## Richard Y. Johnson & Son, Inc.

**Delmarva Christian School  
21777 Sussex Pines Road, Georgetown, Delaware  
Bid Pac A– Contracts 1 thru 18  
May 12, 2025**

### **Addendum No. 5**

SHEET NUMBER: E002

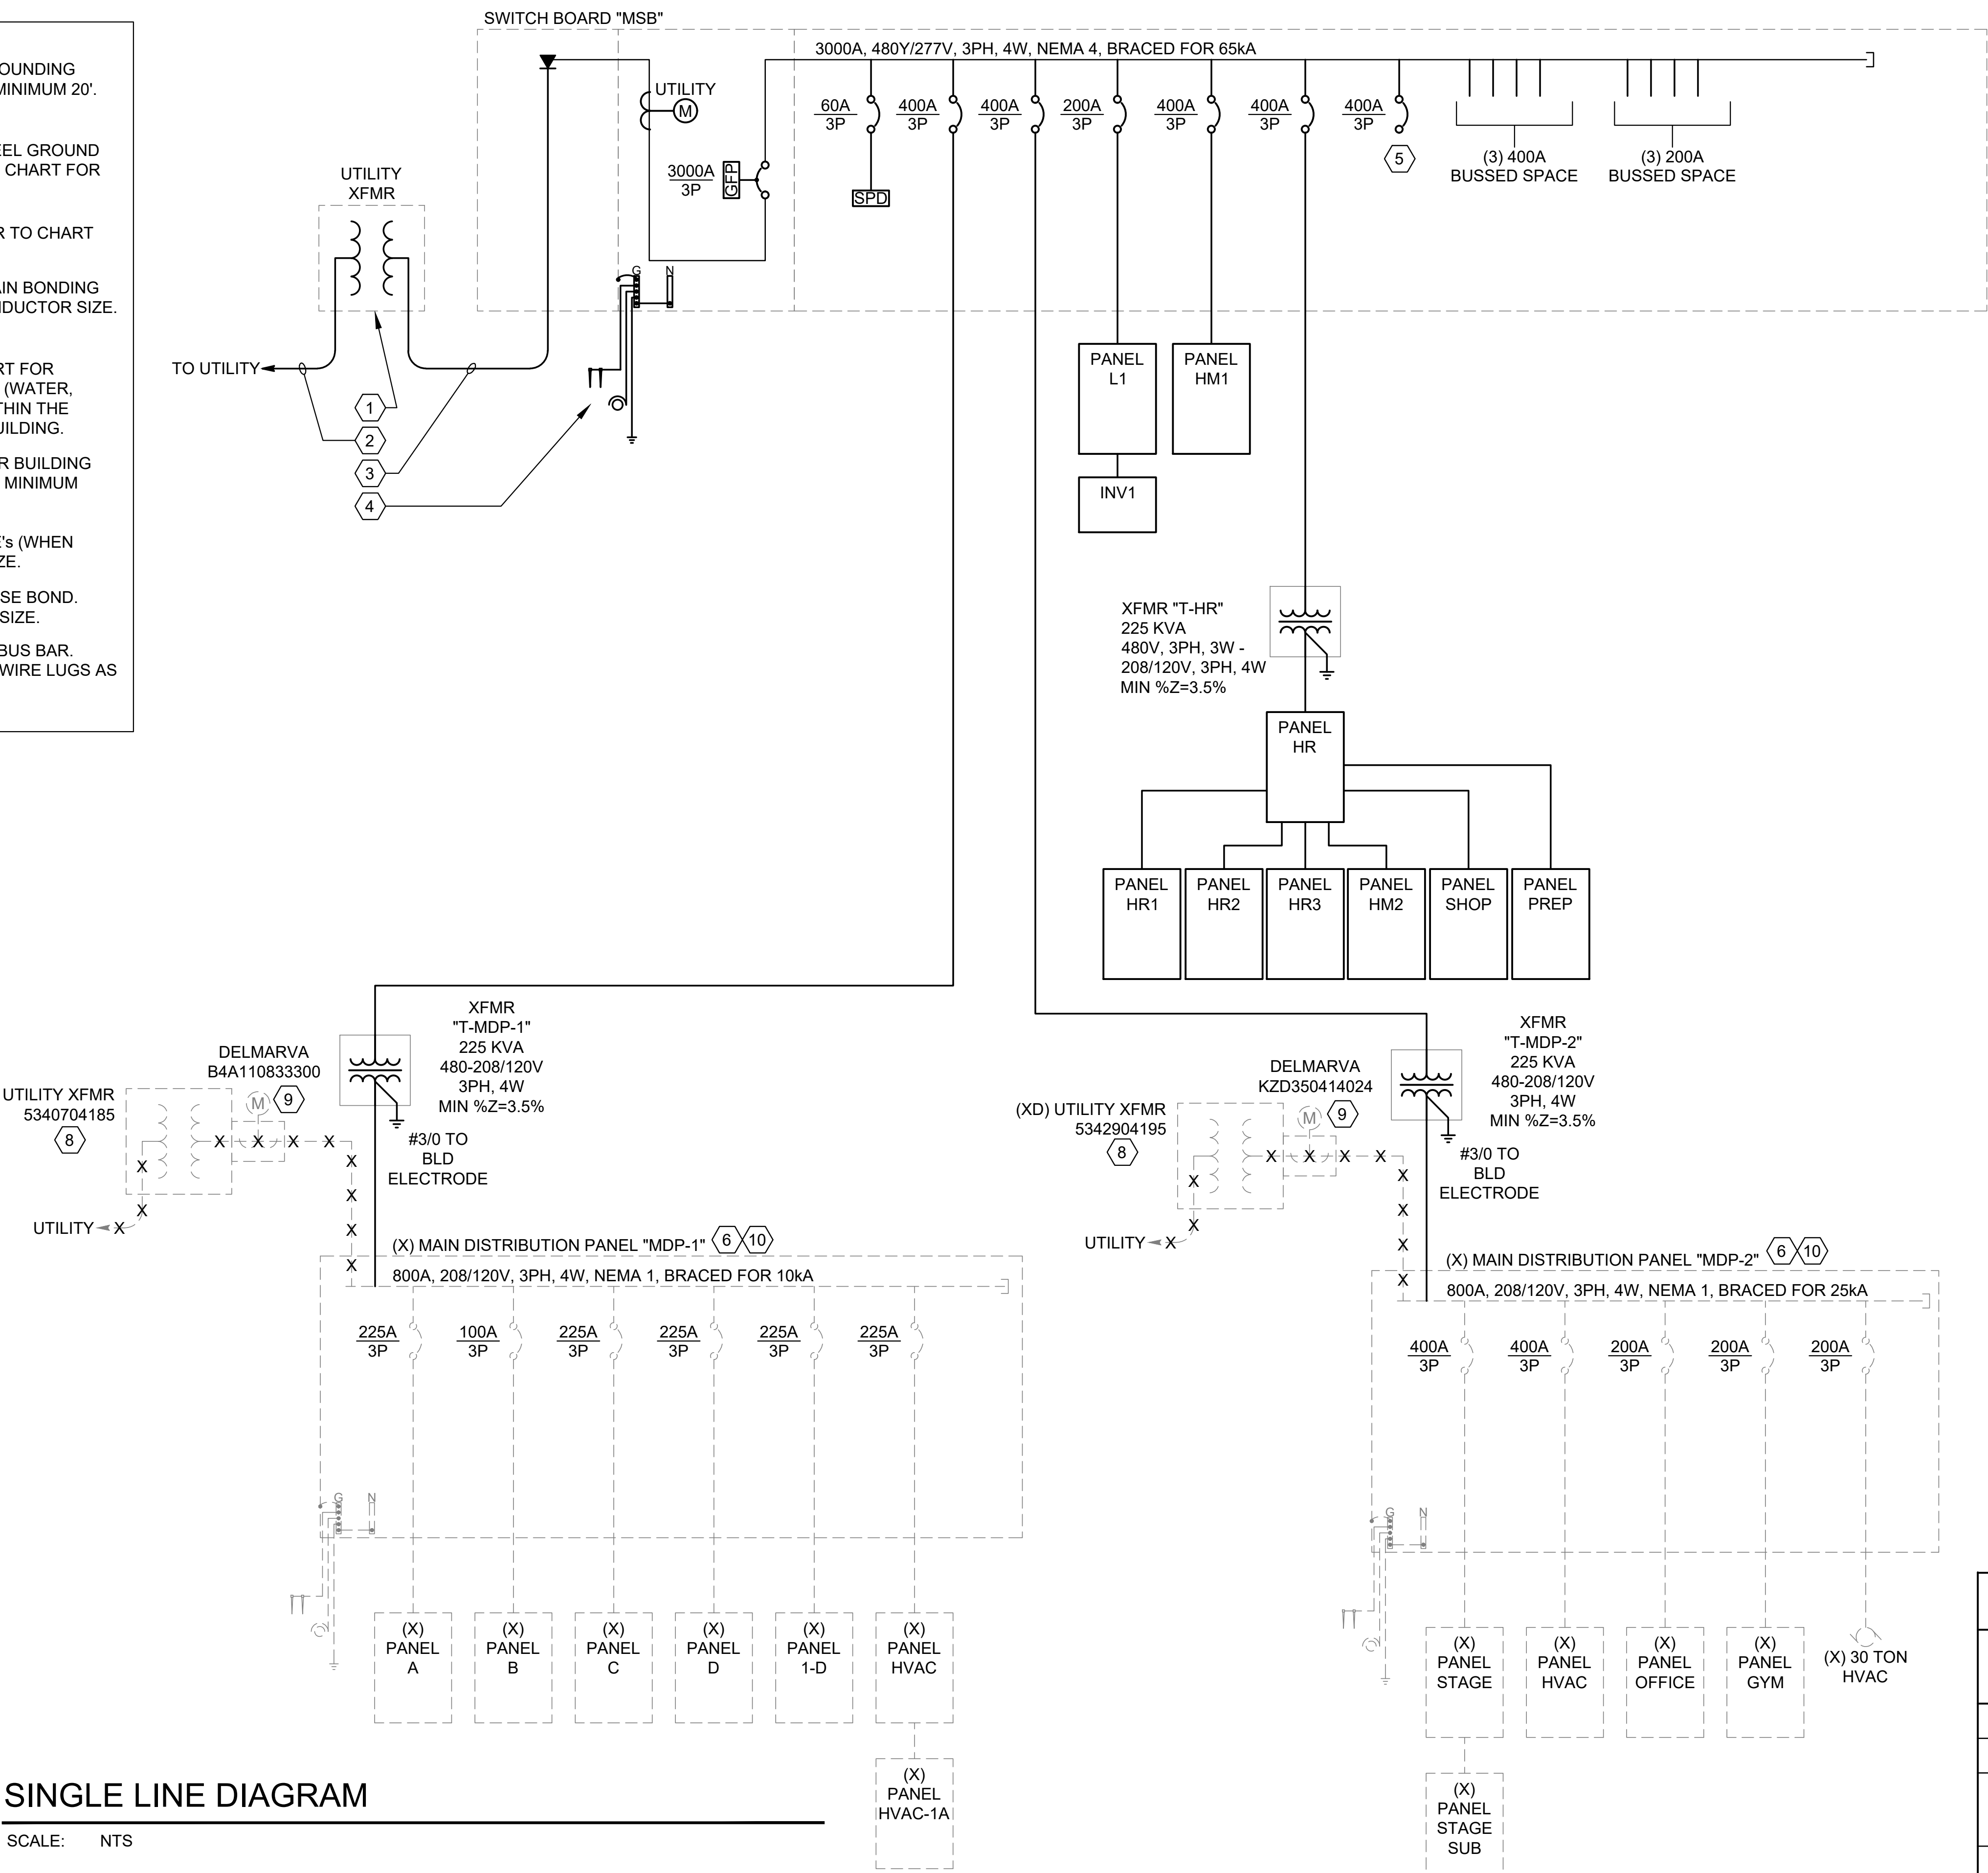
1. See attached Electrical drawings E-002, E-003, E-004, E-005, E-101, E-102, and E-111. Revisions include the following;
  - a. Coordination with PTG design for smartboard layouts.
  - b. Gymnasium equipment power and circuiting. (Bleachers, basketball goals, scoreboards).
  - c. Motorized roller shade power and circuiting
2. Early Childhood Center, Sheet S-003, Add design criteria. See attached.

**POWER FIRST FLOOR PLAN-A**

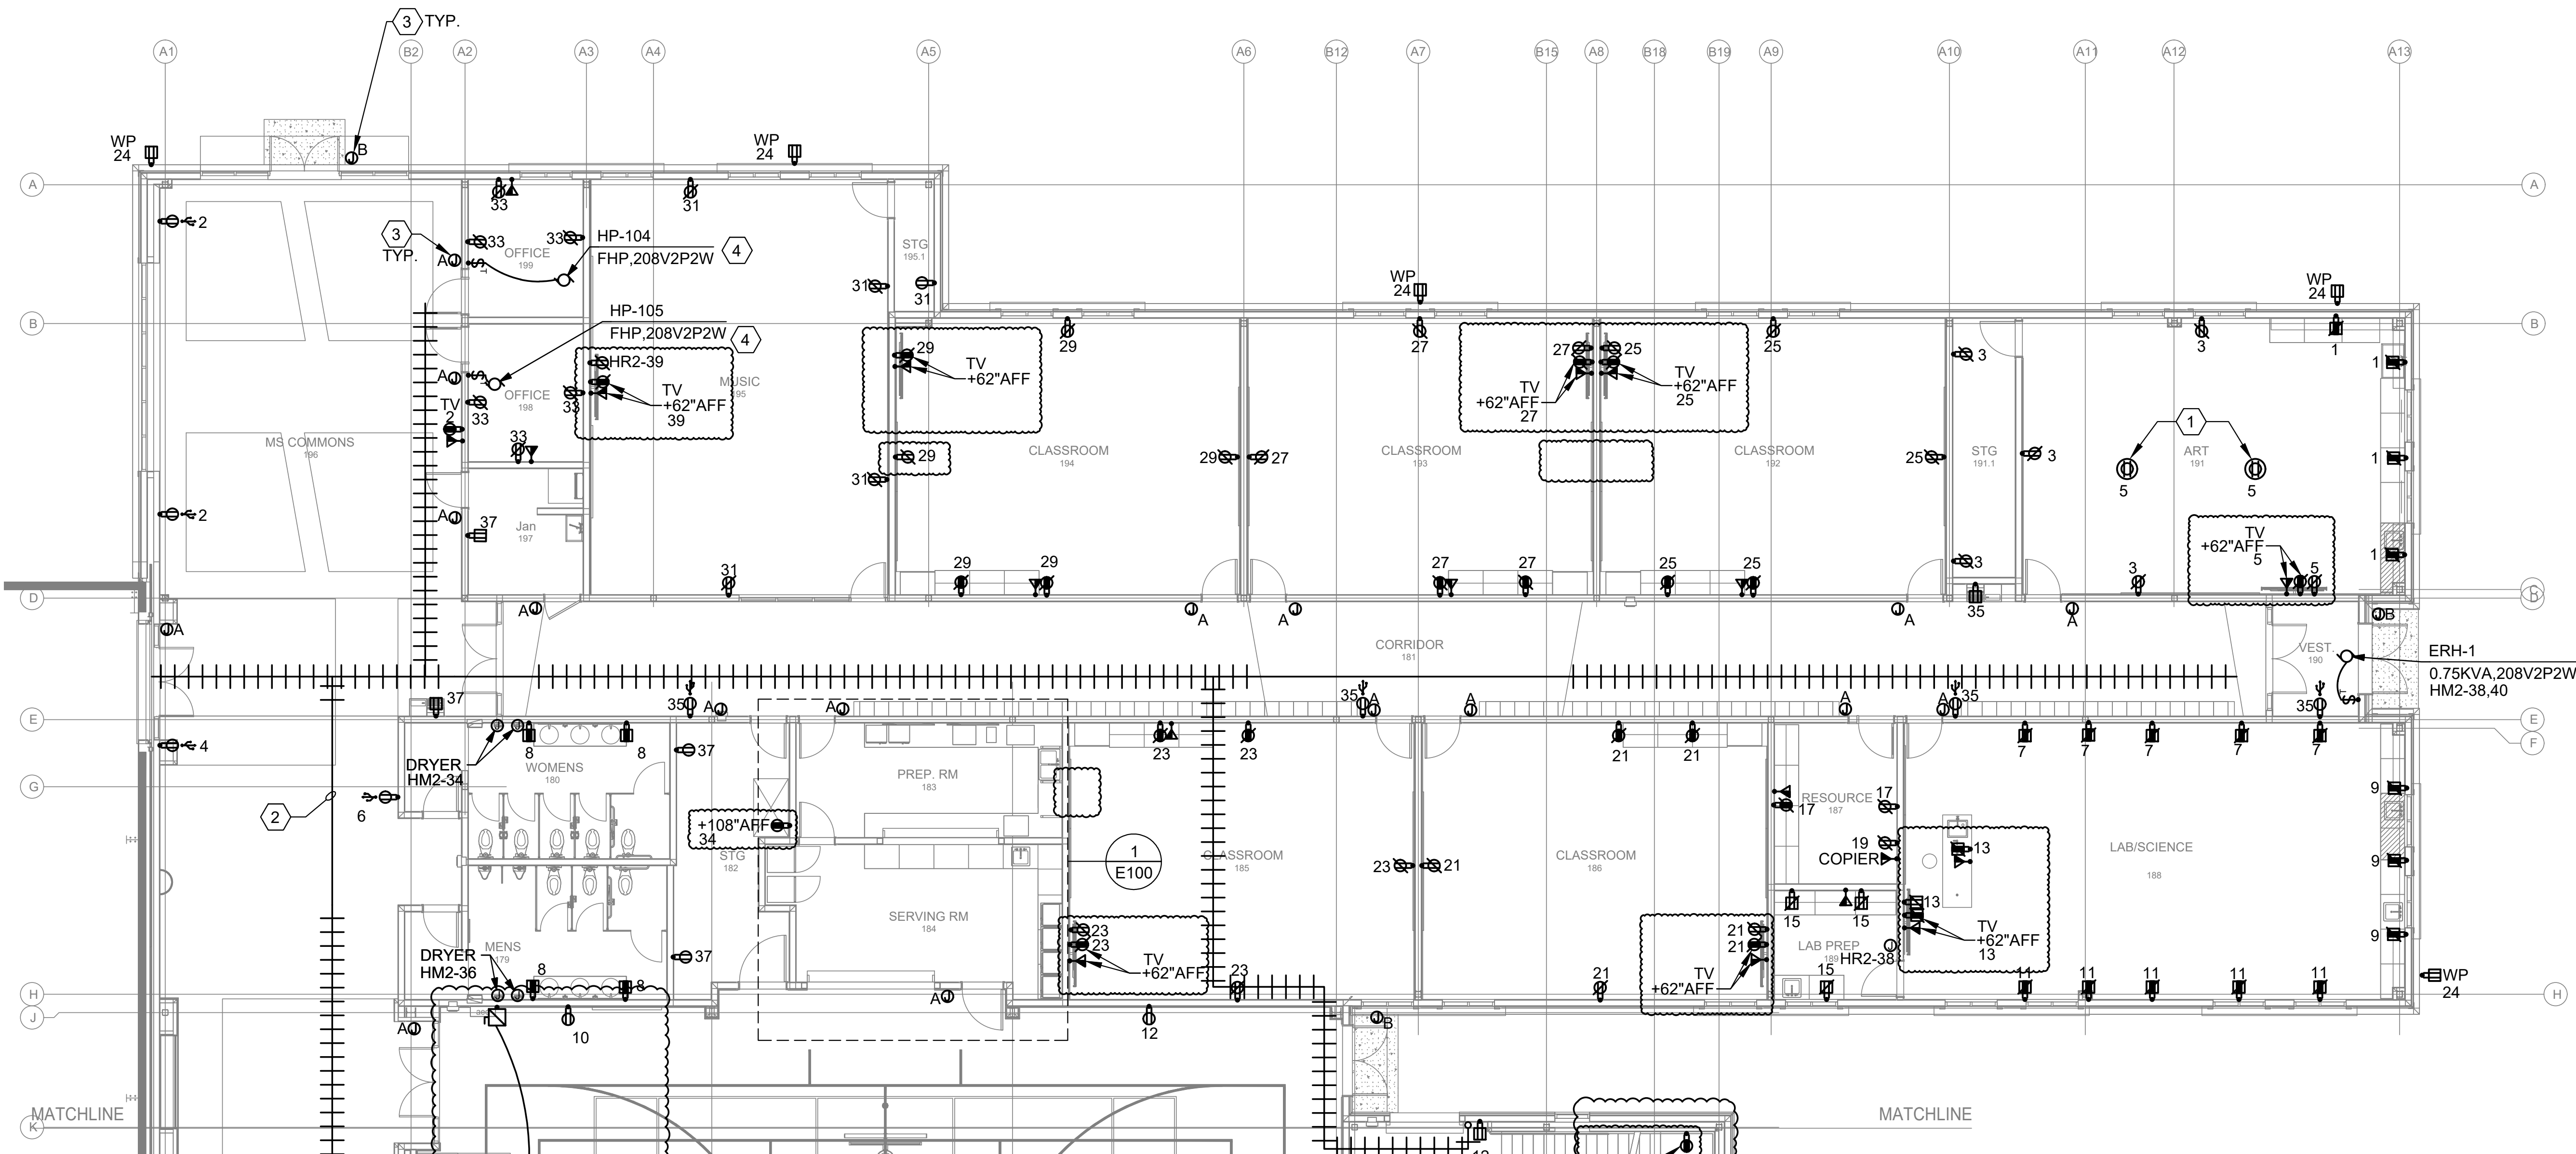
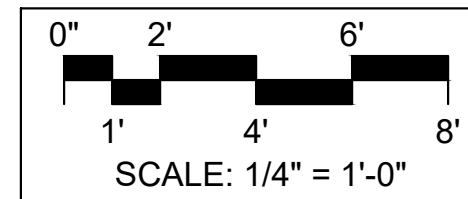
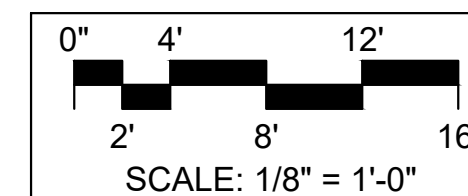
Drawing E101 does not indicate any power supplies or key-switches for the basketball hoops and divider curtain or a power supply for the scoreboard (and potentially shot clocks). Can power supplies be added for this equipment?

Yes, power will be provided for all equipment, see drawing revision.
